Second Preliminary Consultation
MONTGOMERY COUNTY HISTORIC PRESERVATION COMMISSION
STAFF REPORT

Address:	10933 Montrose Avenue, Garrett Park	Meeting Date:	9/9/2020
Resource:	Contributing Resource (Garrett Park Historic District)	Report Date:	9/2/2020
Applicant:	Doug Mader, Architect	Public Notice:	8/26/2020
		Tax Credit:	N/A
Review:	2 nd Preliminary Consultation	Staff:	Michael Kyne
Case Number:	N/A		
PROPOSAL:	Building additions and alterations

1 **FRONT ELEVATION**
dd5 SCALE: 1/8" = 1'-0"

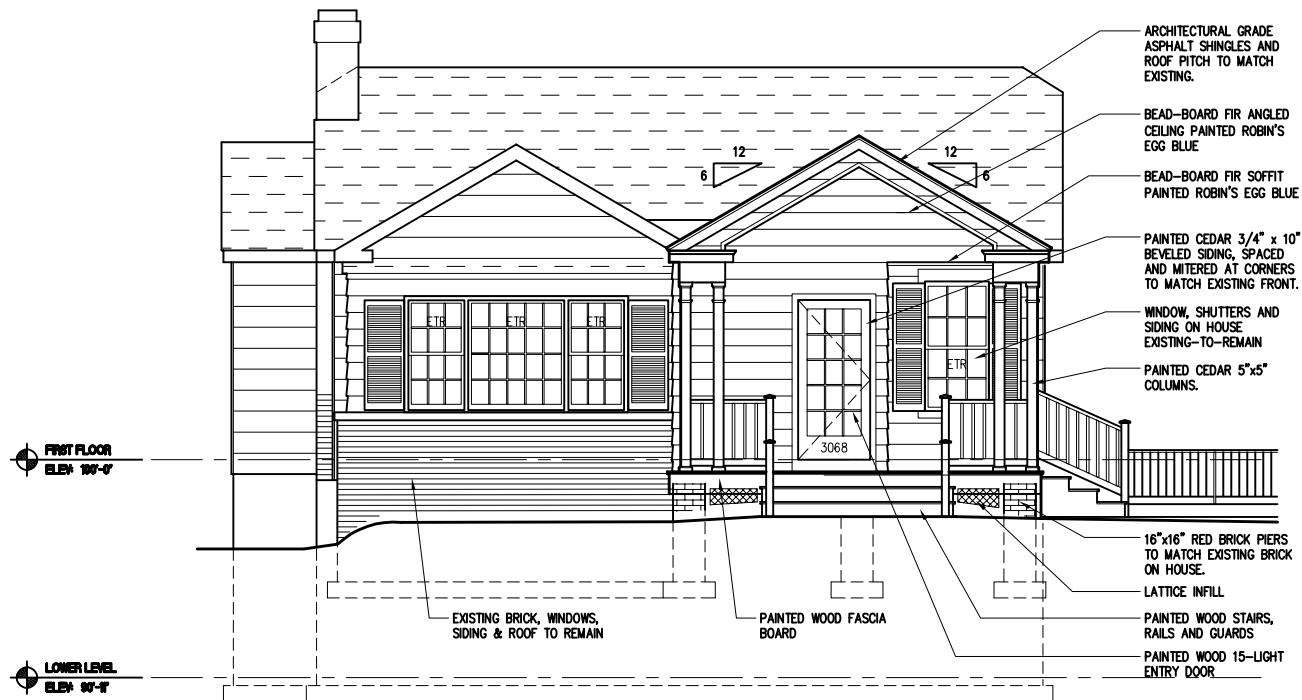
- The Commission found the proposed front additions inappropriate. Specific comments included:
 - The barrel vault ceiling of the proposed front porch is not symmetrical, where it is split by the vestibule.

- The head height of the barrel vault ceiling of the proposed front porch is too high.
 - The front stairs appear to be arbitrary.
 - Matching the width of existing front porch results in too much mass.

- If the front door is being reoriented to face Montrose Avenue, it will be inconsistent with the proposed stairs.
 - The proposed front porch is too large and projects too far forward.

- The proposed front additions should be clearly subordinate to the existing front porch.
 - As proposed, the front additions completely alter the character of the primary elevation.

- The complexity of the proposed front additions makes them incompatible with the otherwise simple house.
 - The vestibule within the porch results in an incompatible feature, which will detract from the streetscape.

- One Commissioner noted a preference for better matching double gables at the front (as opposed to the barrel vault ceiling of the proposed front porch).

Staff continues to express concerns regarding the proposed front additions. As noted in the July 29, 2020 staff report, the *Comprehensive Amendment to the North Bethesda-Garrett Park Master Plan (1992)* states that a Contributing Resource within the Garrett Park Historic District is a property:

Staff remains concerned that the subject property will *not* continue to contribute to the to the character of the historic district and streetscape with the proposed front additions. As noted above, the Commission shared staff’s concerns at the July 29, 2020 preliminary consultation, finding the proposed front additions inappropriate for a variety of reasons. While the applicant has made revisions to address some specific concerns, staff finds that the proposed front additions are still too large and complex (especially with the vestibule addition continuing to be proposed within the front porch addition). The proposed front porch addition continues to project too far forward, and it is not clearly subordinate to the existing features at the front of the house. Therefore, staff finds that the proposed front additions continue to alter character-defining features of the subject property and/or surrounding streetscape contrary to *Standards #2 and #9*.

Staff seeks further guidance from the Commission regarding the appropriateness and compatibility of the proposed front additions, as revised.

THE ARCHITECT AND HOMEOWNERS WOULD LIKE TO
KNOW IF THEY HAVE THE OPTION OF DOING AN
ARCHED CEILING IN THE FRONT PART OF THE PORCH
TO DIFFERENTIATE IT FROM HISTORIC PRECEDENTS,
INCLUDING BOTH ADJACENT NEIGHBORS (10935
MONTROSE AND 10919 CLERMONT).

- The proposed rear addition will be fully enclosed on both the first and second floor.
- The barrel vault ceiling is no longer proposed for the front porch addition.

- As viewed from the street, the proposed front vestibule addition will no longer split the ceiling of the proposed front porch addition.
 - Instead, the upper portion of the proposed vestibule will extend to fill the entire width of the gable of the proposed front porch.

- Paired columns are proposed in lieu of the previously proposed single columns for the proposed front porch addition.
- Wood railings are proposed for the proposed front porch addition.

- Wider, centered steps with wood handrails are proposed at the front of the proposed front porch addition in lieu of the previously proposed steps, which were minimalistic and offset to the left to be in line with the proposed new front door.

- As revised, the proposed front porch addition will be built on brick piers with lattice screening infill between the piers.
- A 15-lite front door is proposed in lieu of the previously proposed two-panel-four-lite front door.

REAR ELEVATION

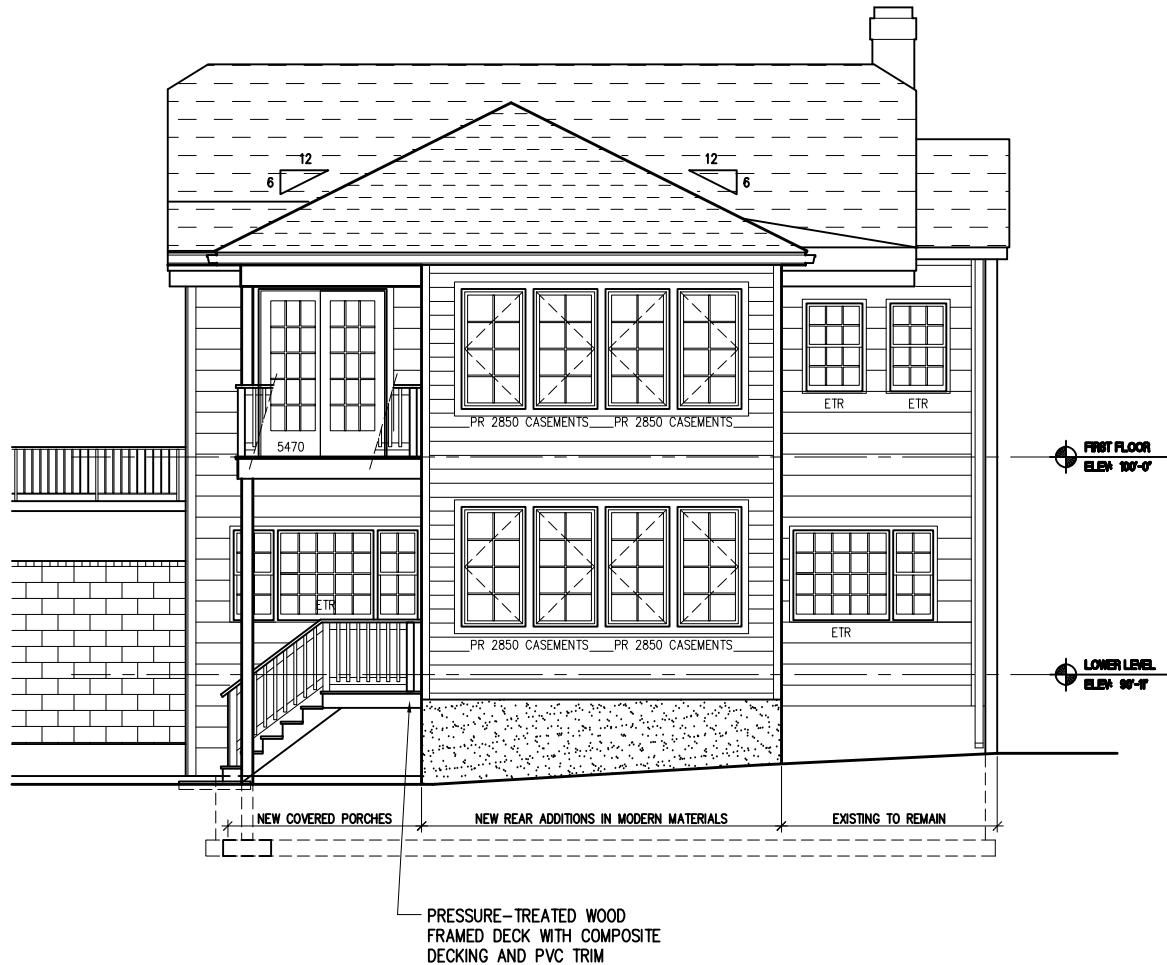
- The Commission found the proposed rear addition (as presented in the 2/28/2020 plans and elevations) to be appropriate, in terms of scale, massing, and location.

- One Commissioner noted that they would prefer the first floor of the proposed rear addition to be enclosed, as the applicants stated it was in their most recent revisions; however, the Commissioner noted that they had not seen these revisions, so they could not yet offer full support.

Staff is generally supportive of the proposed rear addition, as revised. The addition remains in the preferred location entirely at the rear of the historic house, and it will be inset from each rear corner of the historic house, preserving the original outline of the building. Staff continues to find that the proposed rear addition will not remove or alter character-defining features of the subject property and/or streetscape, in accordance with *Standards #2 and #9*. Per *Standard #10*, the proposed rear addition can be removed in the future, leaving the essential form and integrity of the historic property and its environment unimpaired.
